BECK NORTH UNIT 54 JSP16-36

Public hearing at the request of Dembs Development, Inc. for Special Land Use, Preliminary Site Plan, and Stormwater Management Plan approval. The subject parcel is located in Section 4 east of Nadlan Drive and north of West Road. It is approximately 5.02 acres and zoned I-1 (Light Industrial). The applicant is proposing to build a 67,000 square foot speculative building in the Beck North Corporate Park with associated site improvements.

PLANNING REVIEW

Re: Beck North Unit 54 (JSP16-0036)
 Woodland Review of the Preliminary Site Plan (PSP17-0016)

CLIENT: DEMPS DEVELOPMENT, INC.
 PRELIMINARY SITE PLAN
 BECK NORTH CORPORATE PARK - UNIT 54
 SECTION: 4
 TOWNSHIP: 1N
 CITY OF NOVI
 RANGEBE
 OAKLAND COUNTY
 MICHIGAN

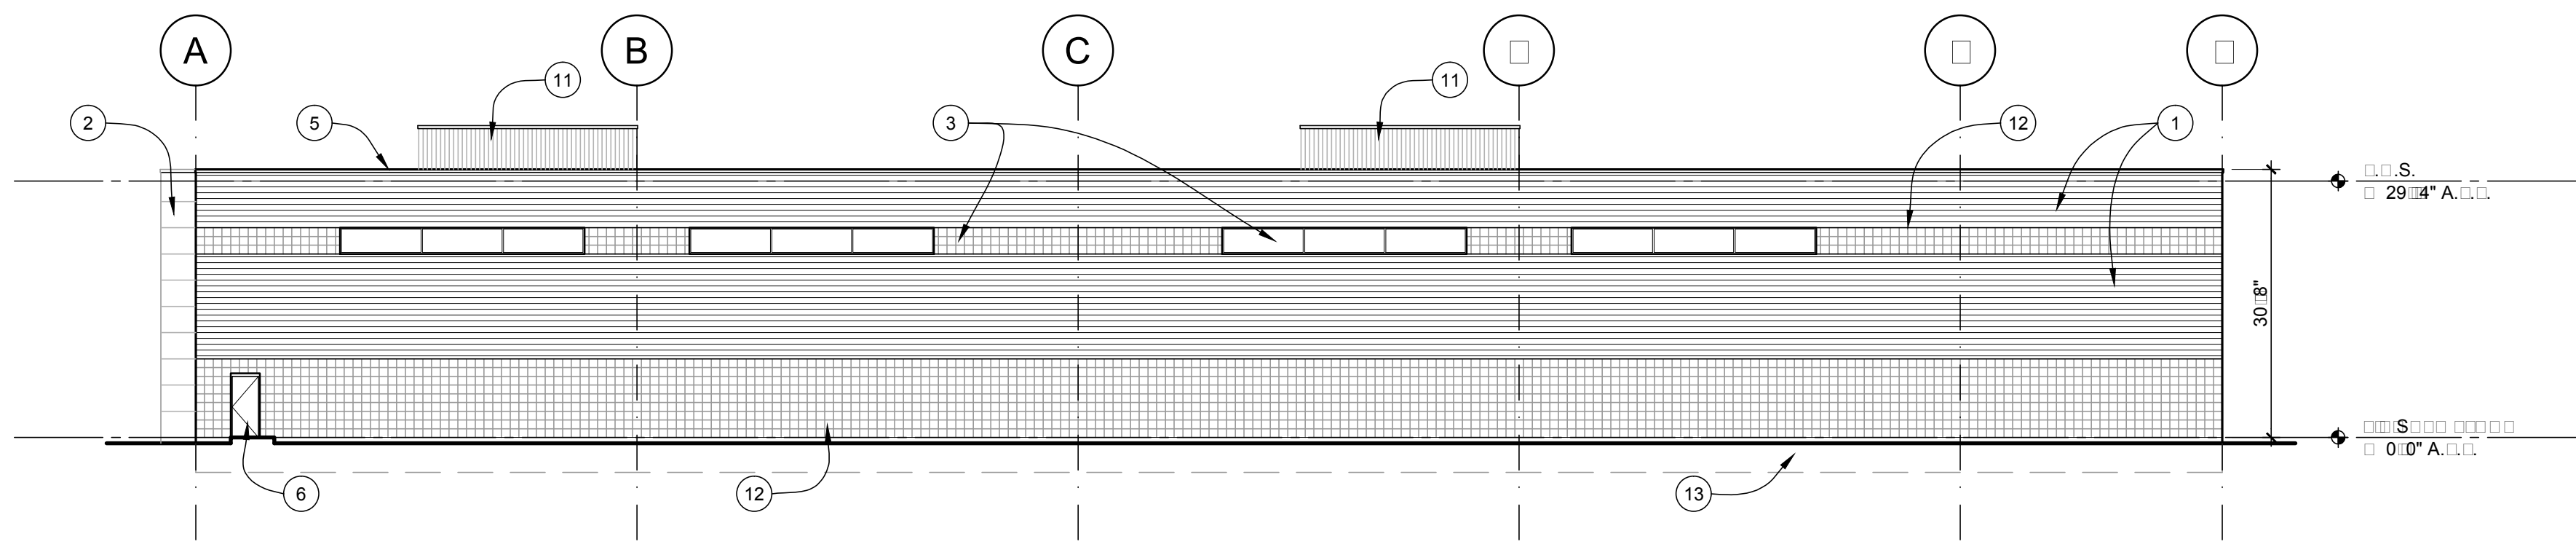
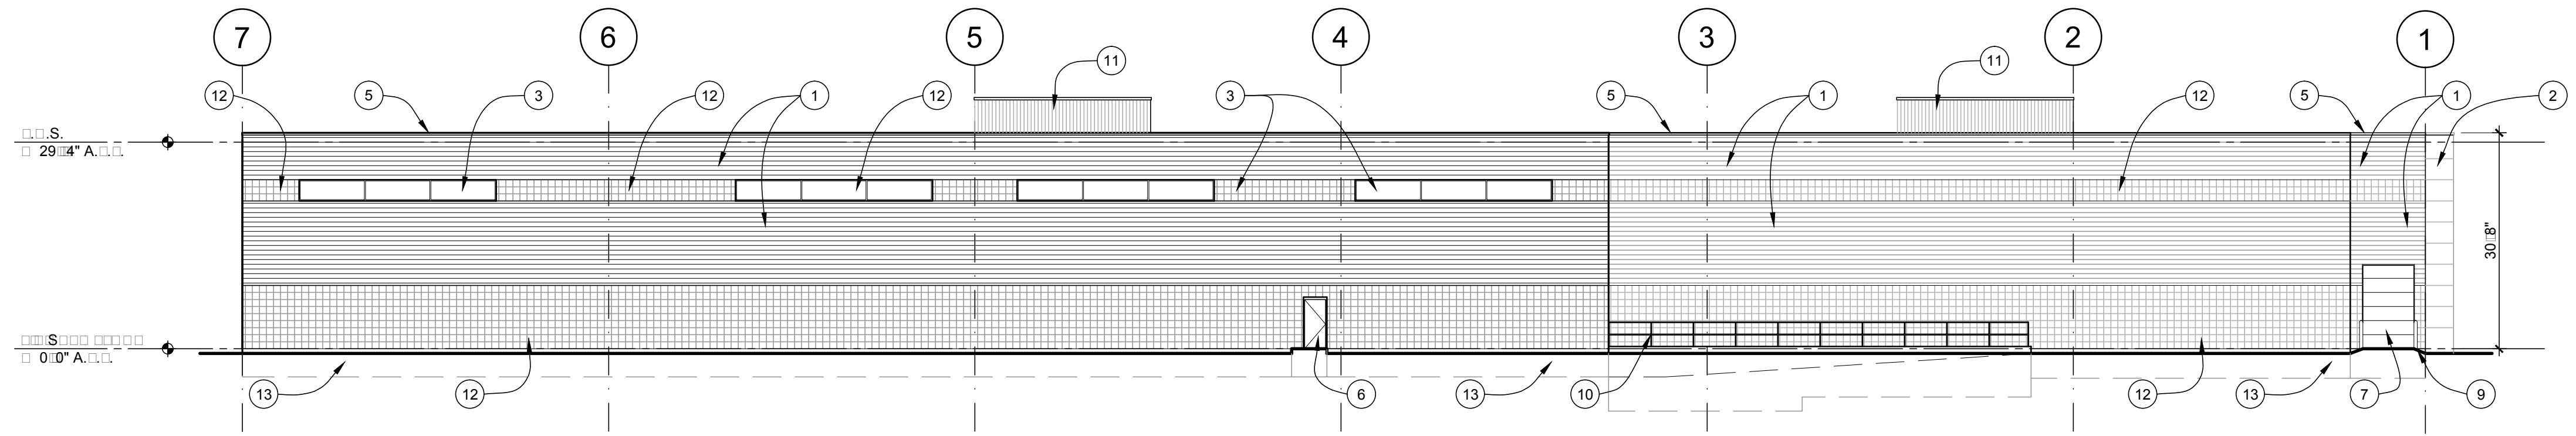
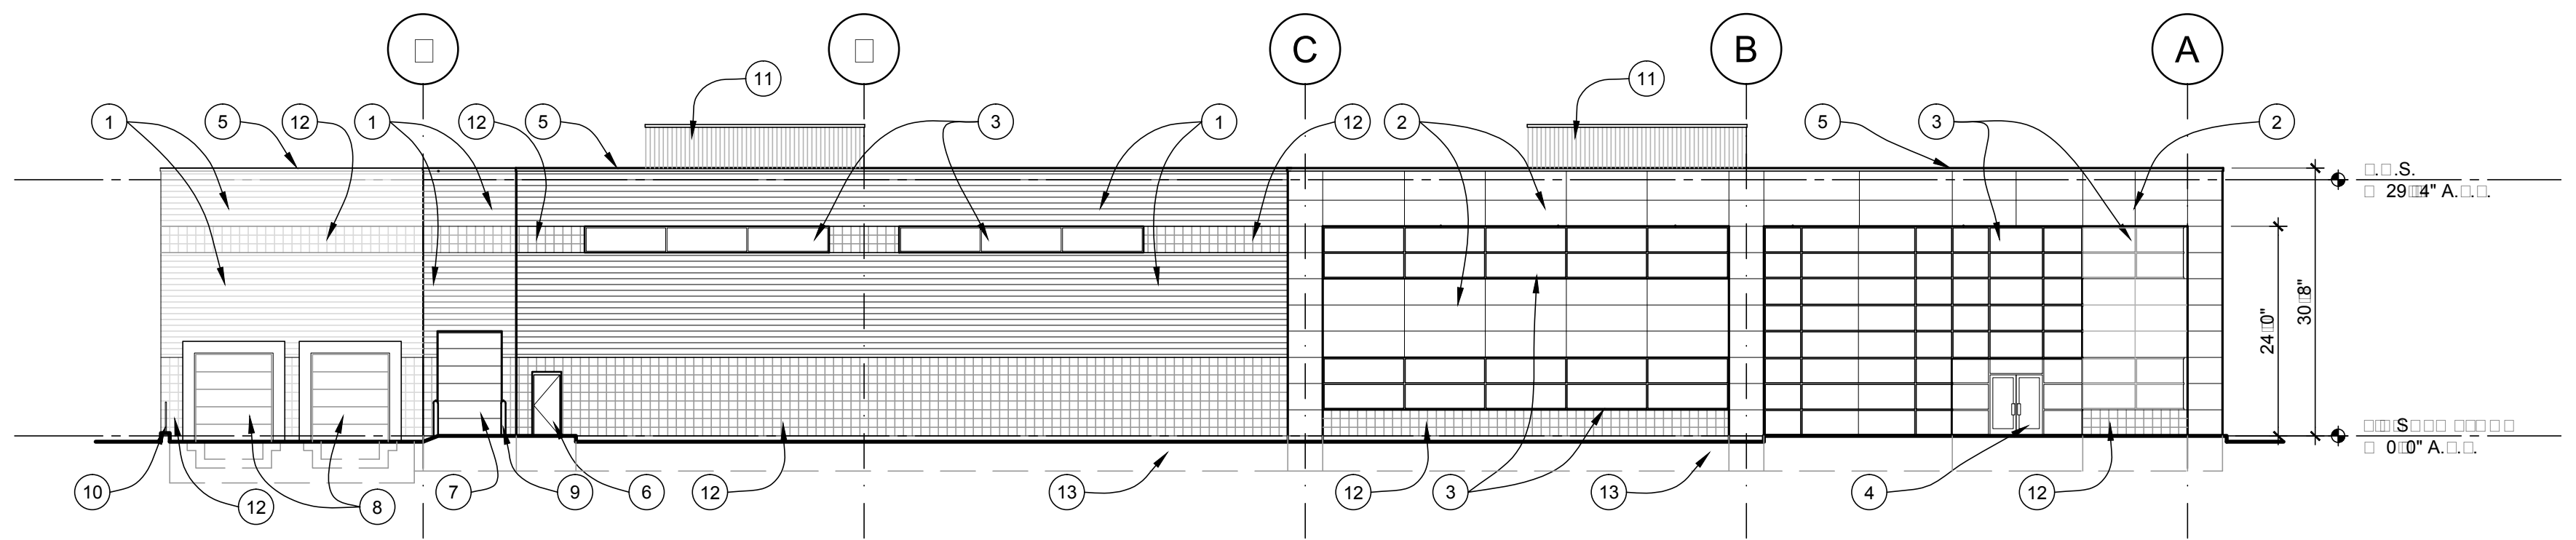
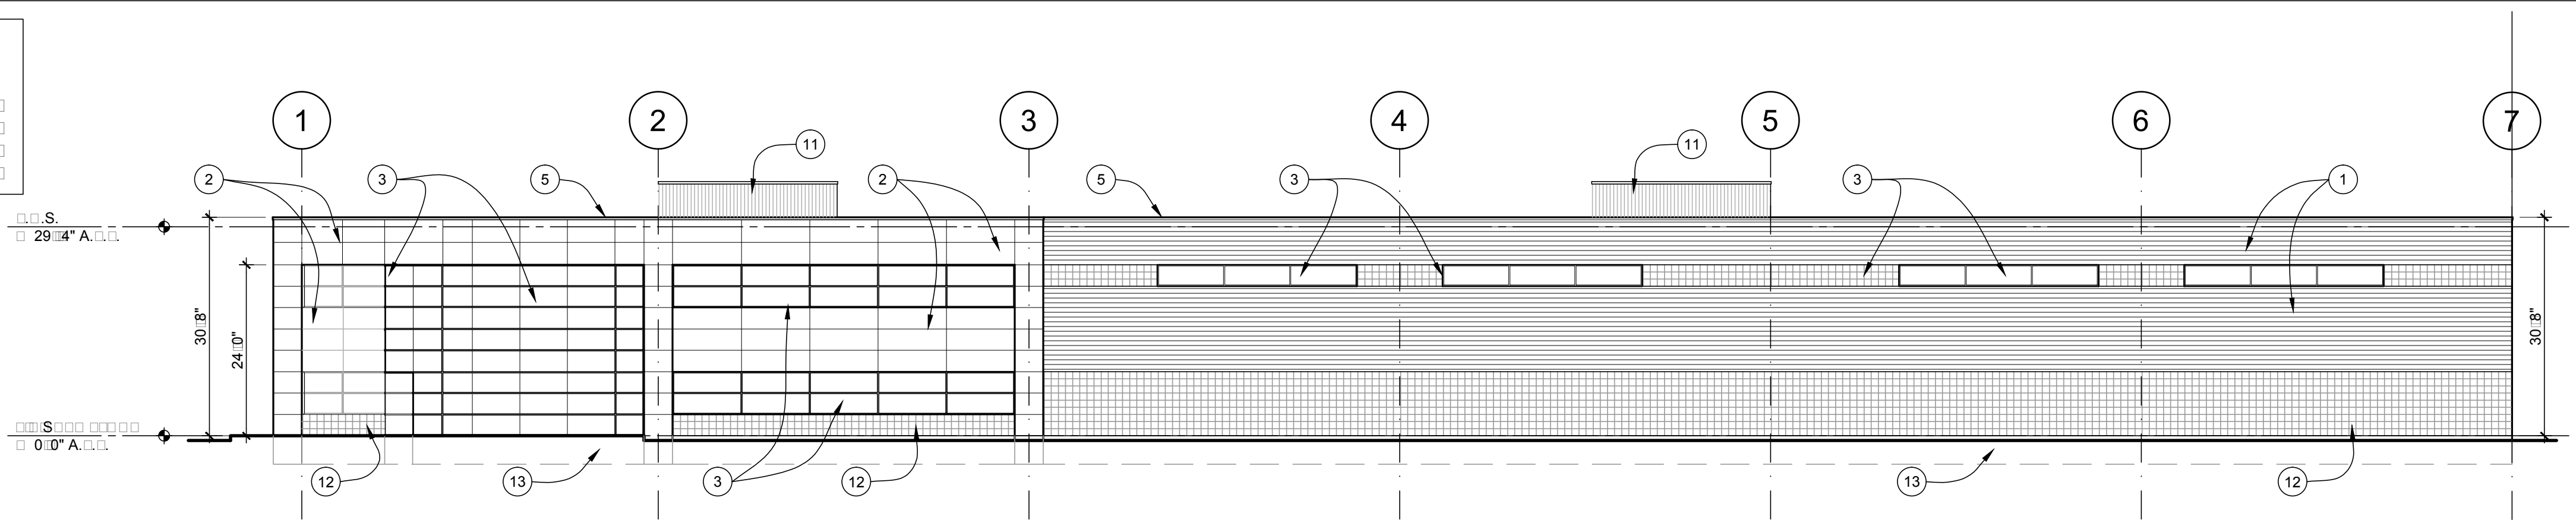
1. Off-Street Parking in Side and Rear Yards (Sec. 3.6.2.F): Shall not occupy more than 50% of the area of the side or rear yard abutting a residential district. **Provide calculation for the east side yard only in order to verify conformance.**
2. Parking Calculations (Sec. 5.2.12): Refer to chart for more details. **Once the tenant is known, the parking calculations will need to be updated in order to verify conformance with the ordinance.**

6. Off-street loading/unloading (Sec. 3.14.5.A): There is a drive along the east side of the building. **The drive on the east side of the building shall not be used by trucks to access the loading docks. Some signage should be proposed on site to eliminate this option and a note should be considered placed on the site plan.**

1. The property does not meet the minimum frontage of 300 feet required to allow more than one full service driveway entrance to the site. A secondary gated "emergency only" access drive is allowable.
2. Two points of access are required for fire safety. Consider ingress/egress easements and/or a combined drive approach with adjacent parcel and existing drive approach.
3. A driveway spacing waiver, granted by the Planning Commission, would be required for any new driveway entrance on this property within 105 feet (measured from edge of near curb to edge of near curb) of any other existing or proposed drive approach.
4. Soil borings shall be provided for a preliminary review of the constructability of the proposed development. Borings identifying soil types, and groundwater elevation should be provided at the time of Preliminary Site plan.

5. Provide notes on the Grading plan to match existing grades at any driveway paving in the right-of-way.
6. Clarify parking block locations and effective length of parking stalls where parking blocks are used.
7. Provide dimensions of parking stalls to the face of curb or walk. Other dimensions may be to back of curb and noted accordingly.
8. Provide at least a 3 foot buffer distance between the sidewalk and any fixed object including fire hydrants and light poles.
9. End islands shall conform to City standard island design, or variations of the standard design maintaining conformance with Section 2056 of Appendix A of the Zoning ordinance (i.e. 2 foot minor curb radius, 15 foot major curb radius, minimum width of 8 feet, 3 feet shorter than adjacent 19 foot parking stall).

1. Based on the vehicular use areas, 3,150 sf of landscape island area and 39 deciduous canopy trees are required. Per the plan, 3,150 sf of islands and 39 trees are provided.
2. **Please check the areas of some of the interior islands. Some appear to be smaller than the SF callout, but there are also some end/peninsula islands that could be used to make up any shortfall that may exist.**
3. **Please widen the landscape area adjacent to the walks leading from the parking lots to the side doors on the west, north and south sides of the building to at least 10 feet and plant deciduous canopy trees in those areas to help shade the parking lot and break up the extent of paving.**

1. Based on the 1780 lf of perimeter, 51 canopy trees are required (1/35lf). 23 canopy trees are proposed and a landscape waiver is requested for the 28 trees not provided.
2. While there isn't room for all 51 trees, it appears that at least 3 more perimeter trees could be added, at the expense of woodland replacement trees on the plan. Woodland replacement trees should not replace required perimeter trees.
3. **Please reduce the amount of the waiver request as much as is reasonably possible without overcrowding the site. The waiver will be supported if this is done.**

1. The plant list provided conforms to the requirements of the city.
2. **Please consider substituting some of the burning bush shrubs in the foundation plantings with another species that is not as invasive as the burning bush can be.**
